SIB 11 08 21

Recall 21V-907: Exhaust Gas Recirculation (EGR) Cooler – N57T High Temperature

This Service Information Bulletin (Revision 3) replaces SI B11 08 21 **dated March 2022**.

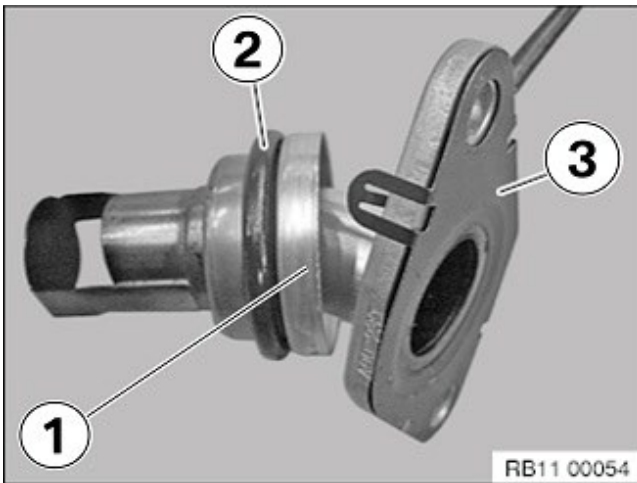
- When the old EGR cooler is removed:

- Remove the EGR pipe from the intake venturi pipe (replace O-ring (2) and gasket (3)).

- Inspect and clean (if needed) the EGR pipe. Wear protective equipment (eyes and hands) and clean out the excessive carbon using a degreasing agent and a brush (suitable brushes can be found in wheel brush kit 83 19 2 298 237).
- Reinstall the EGR pipe with new gasket and O-ring before installing the new EGR cooler.

- Replace the coolant pipe from the Auxiliary EGR cooler to the coolant pump distribution block (1)

- NOTE: The new coolant line PN 11 14 7 827 410 is routed in a different location than the original line (1)
